Title	01 Baseband (MT6253)	
Size A2	Document Number: MT6253 Beta Site Phone	Rev V3.0
Date: Tuesday, April 20, 2010	Sheet 1 of 9

Title: 02 Power & PMIC (MT6253)
Size: A2 | Document Number: MT6253 Beta Site Phone | Rev: V3.0
Date: Tuesday, April 20, 2010 | Sheet 2 of 9

1. FM 的I2C线上串两个4.7K电阻，R706，R707
2. 电池连接器型号改为：PAN37-03423-1002
3. SIM 卡封装改为：CAF99-06183-1503
4. 耳机接口型号改为：JAF00-06506-0100，以后以此为标准，MTK强烈建议添加3个1nF滤波电容。
5. 删除R316，R317 的兼容，直接把音频线接上去。
6. USB与下载的切换电源改为VIO，控制接口改为GPIO40,删除了几个GPIO的兼容
7. T卡型号改为：SG-TFS-006 1.85mm高
8. TV 的PWR 使能信号改为GPIO29
9. 按键去掉扩展芯片，直接使用CPU按键矩阵。FM的I2C换到GPIO29，GPIO30
10. LCD 使用BL900 上的MHb583F1，更改数据线位置

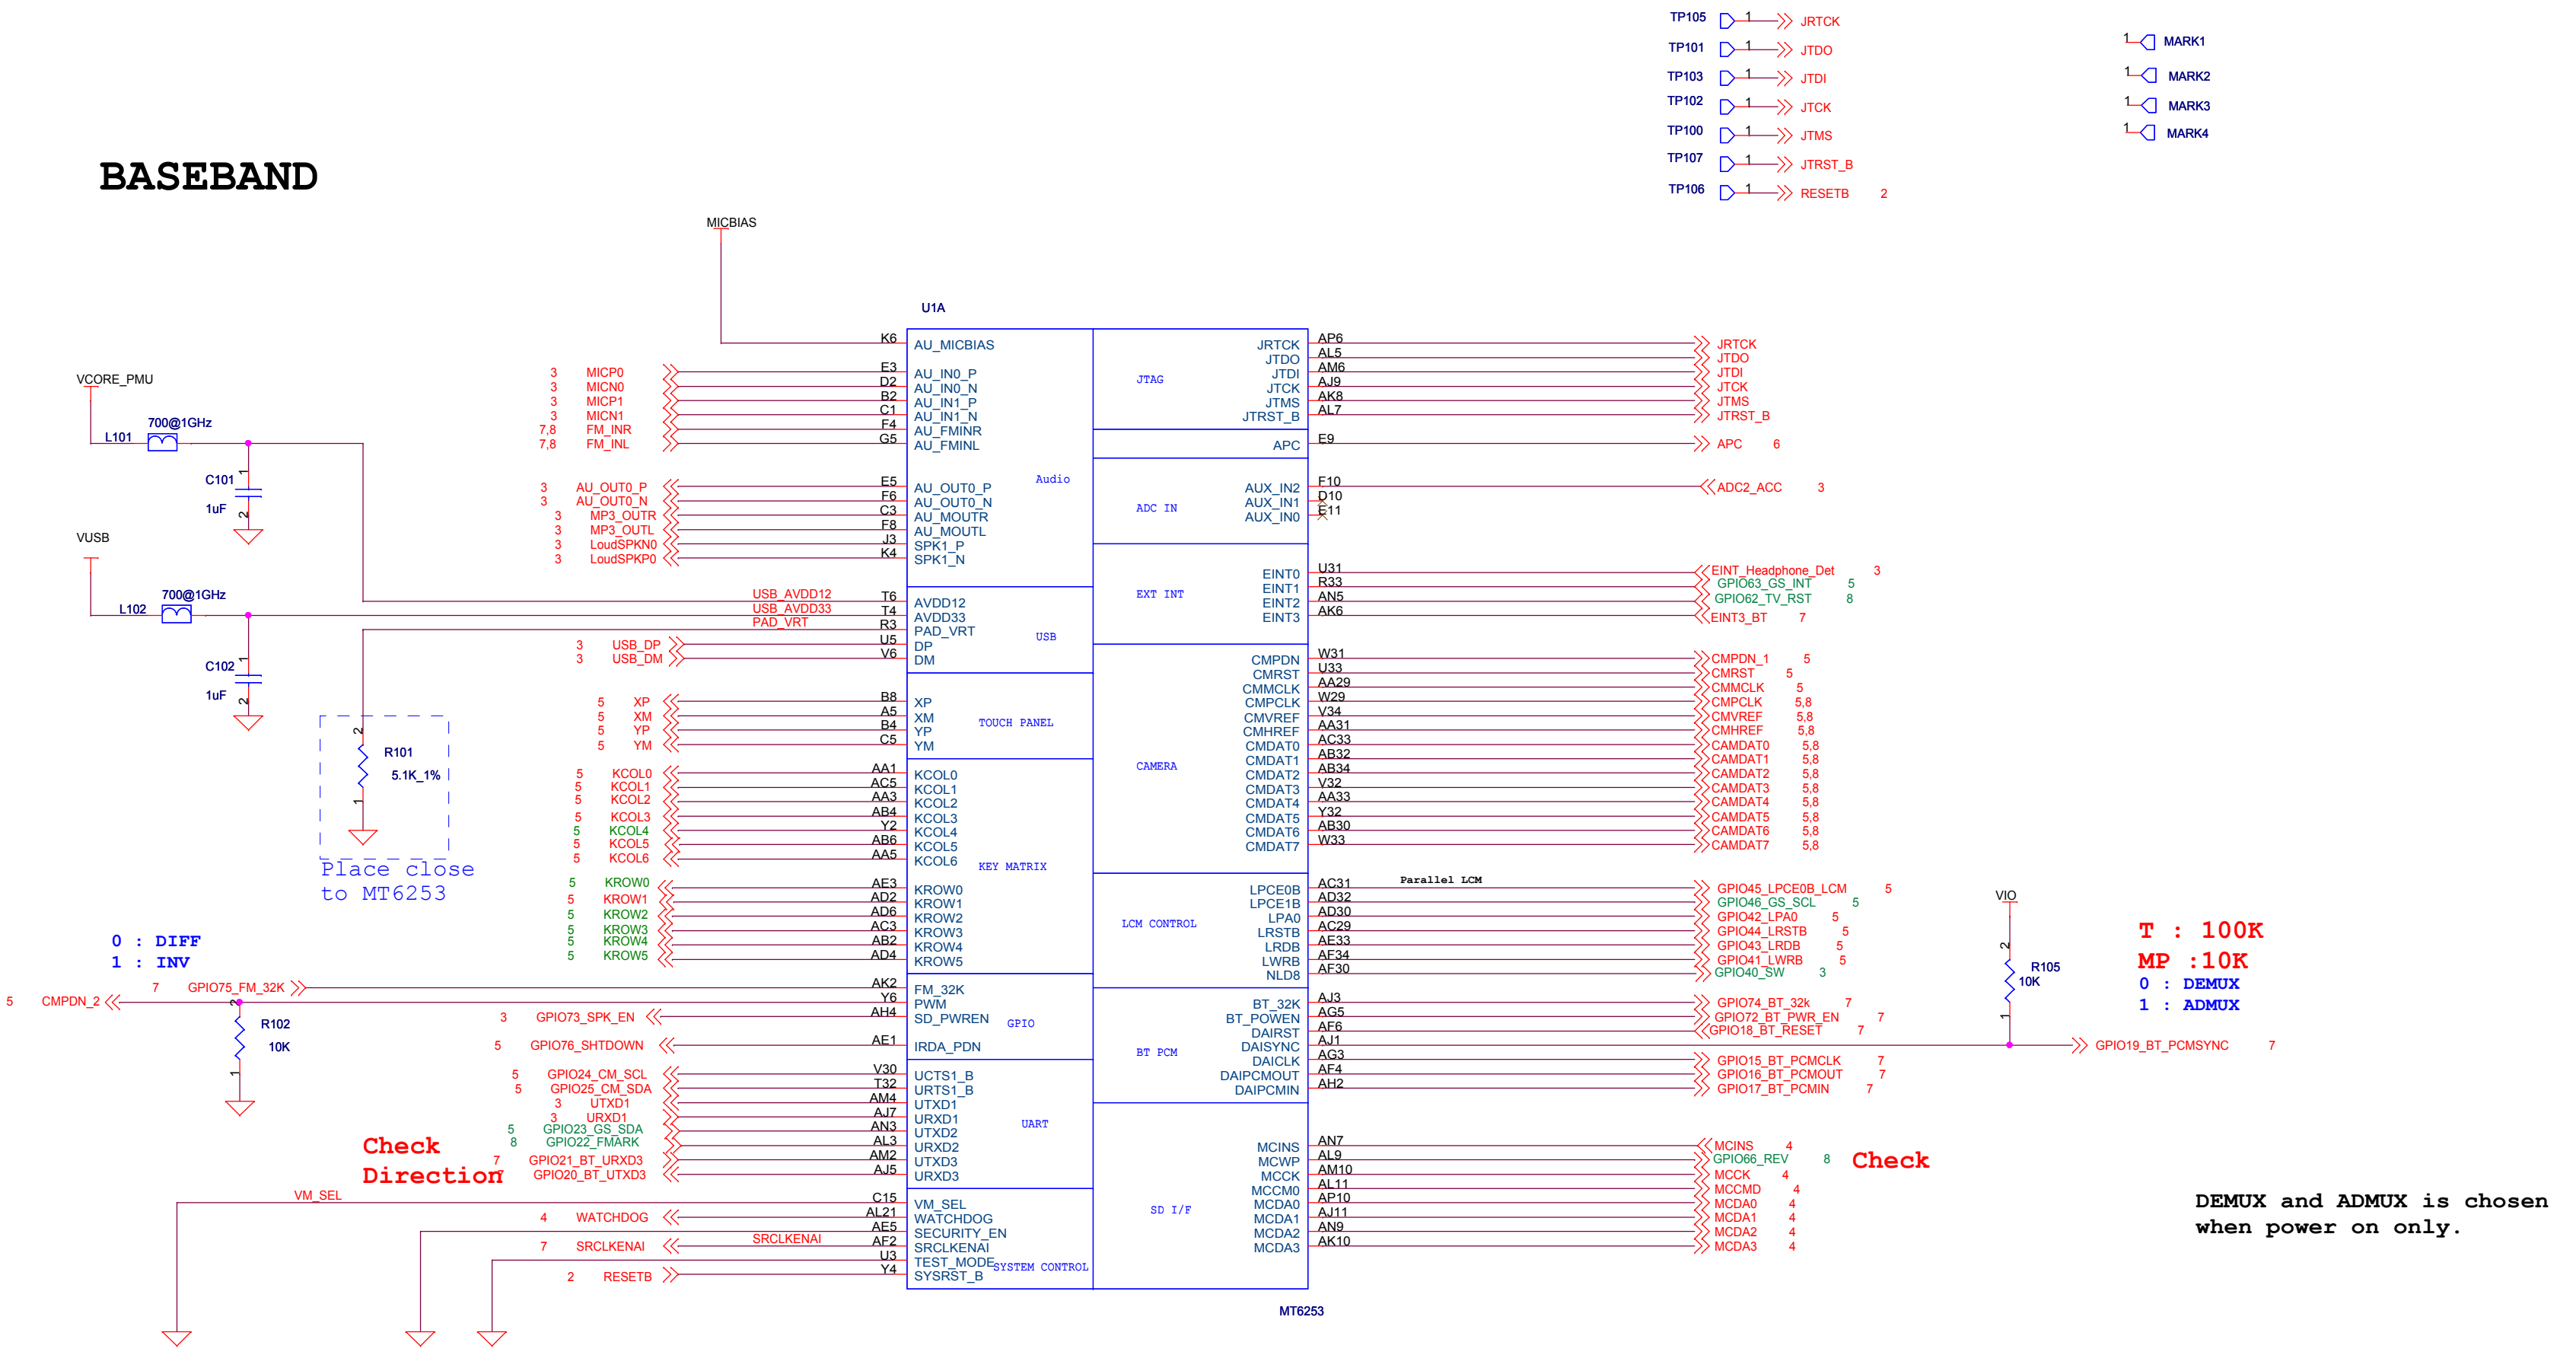
LZ 0628 DELETE KCOL4;
ADC0_LCM_ID

LZ 0626 change KCOL5 tobe FM SCL;
Add KROW4,Krow5, in according to Konka's SCH;
LZ 0701 DELETE FM_32K CLK;
LZ 0702 DELETE SECRITY_EN NET;

Title	07 MT6612		
Size A2	Document Number	MT6253 Beta Site Phone	Rev V1.0
Date:	Tuesday, April 20, 2010	Sheet 7 of 9

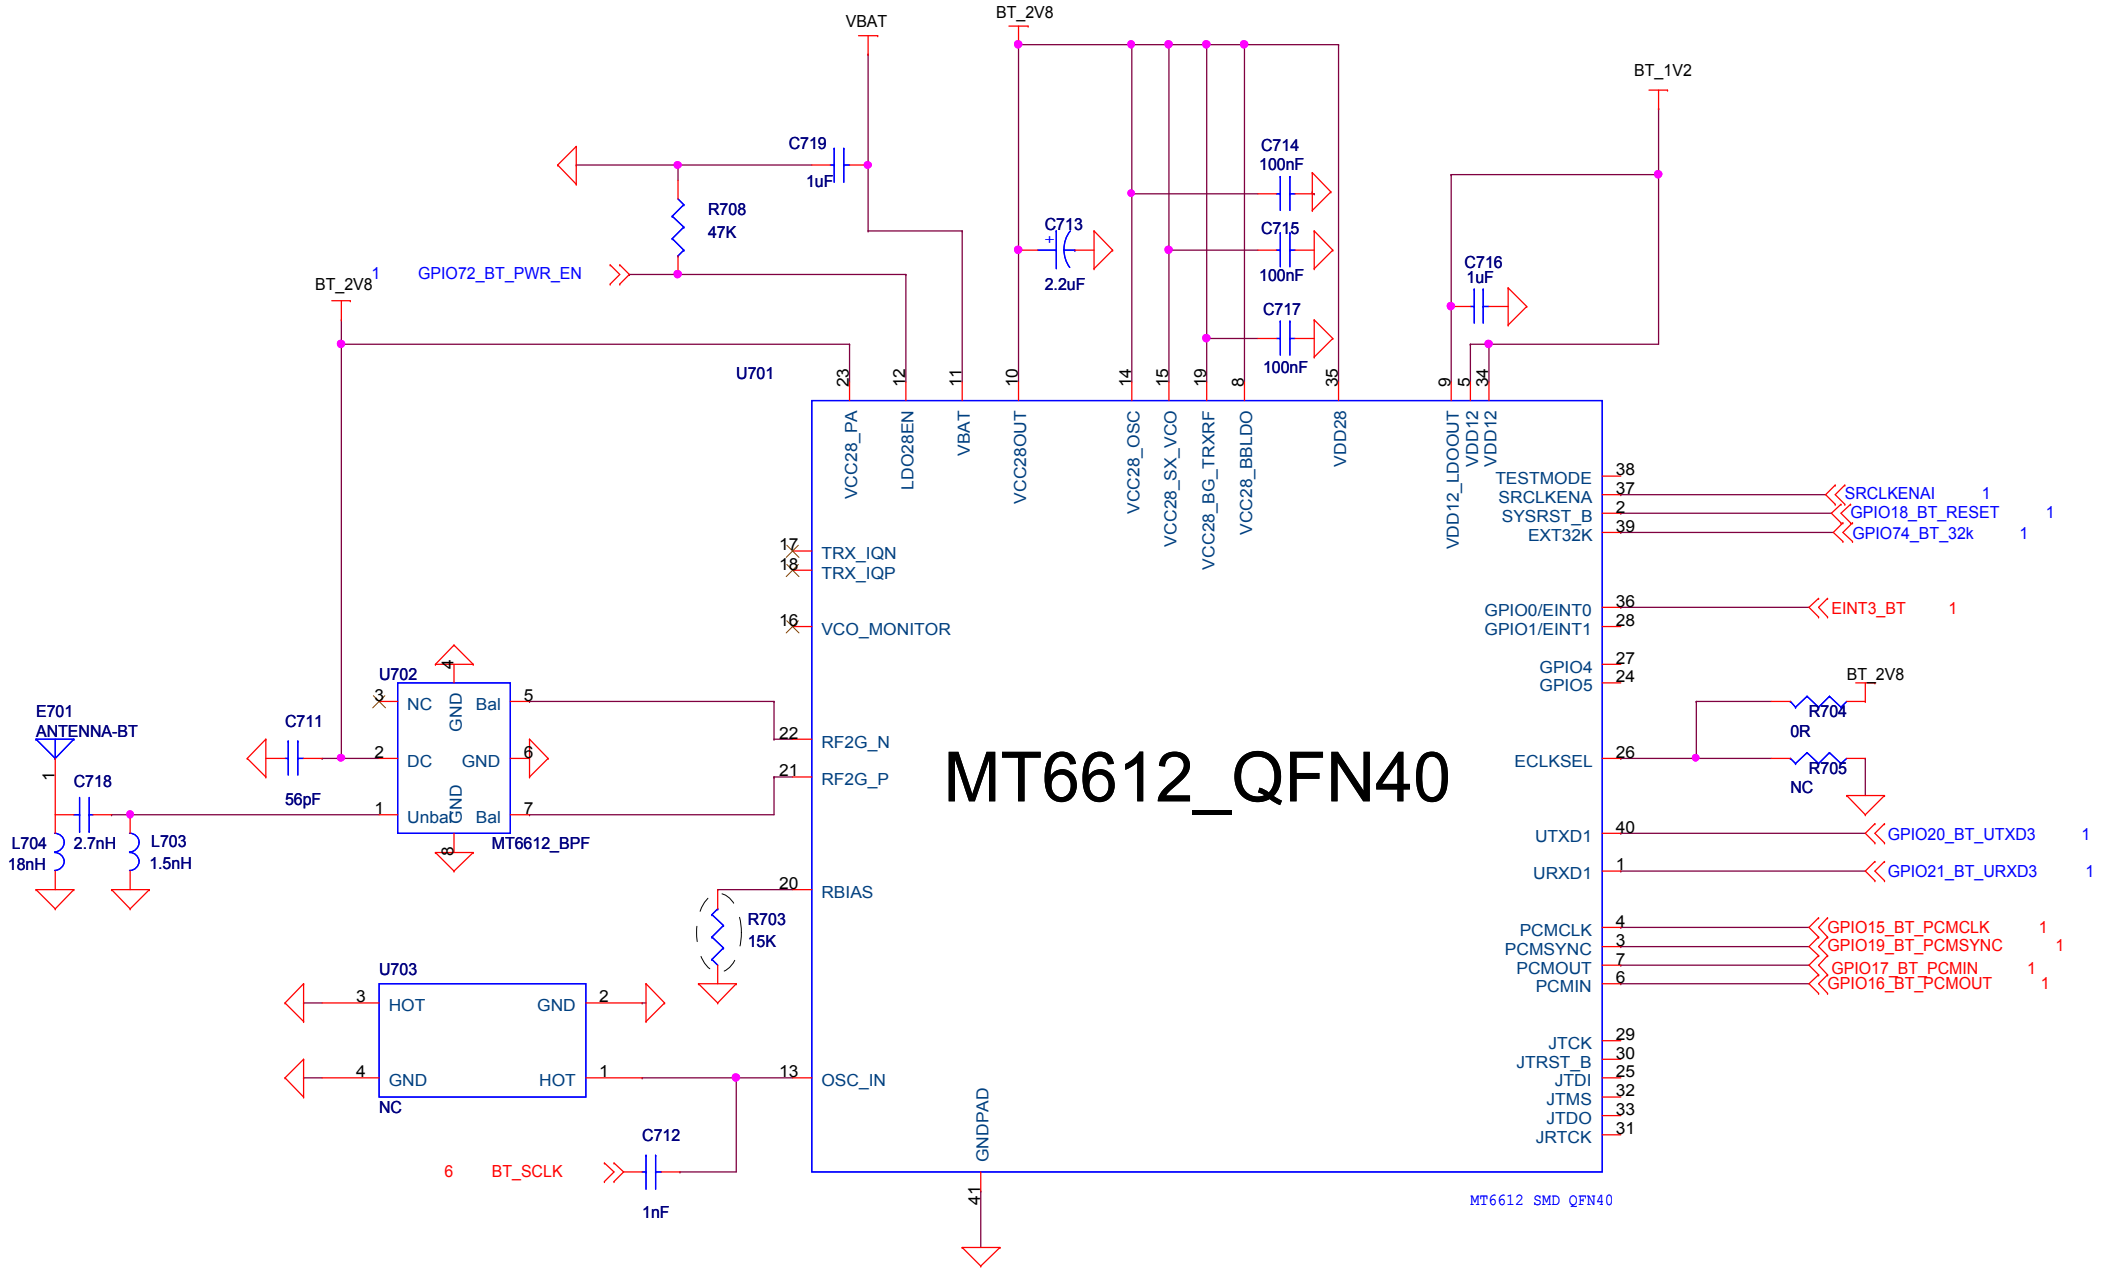
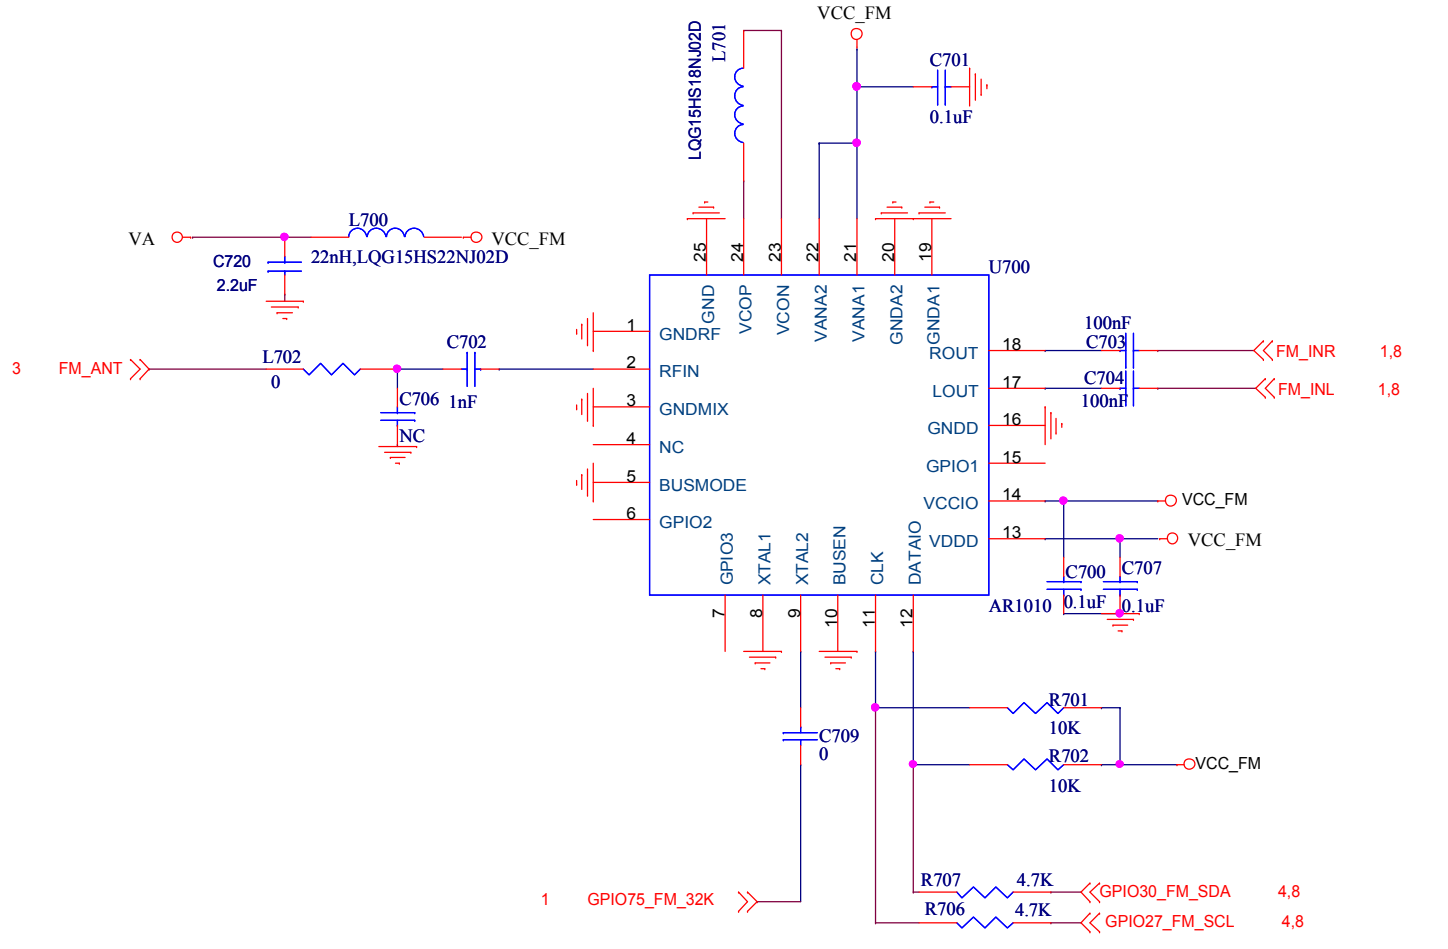
1. If no WIFI, use WIFI_32KHZ to feed FM

2. WIFI, BT, FM 32KHz can't be shared
for each others.

LZ 0630GPIO24，28用作復用PCM；這里NC.
GPIO4，GPIO5用于處理和Wifi的沖突，這里無WIFI，NC；
GPIO1 used for HW flow control,compatible for other platform.
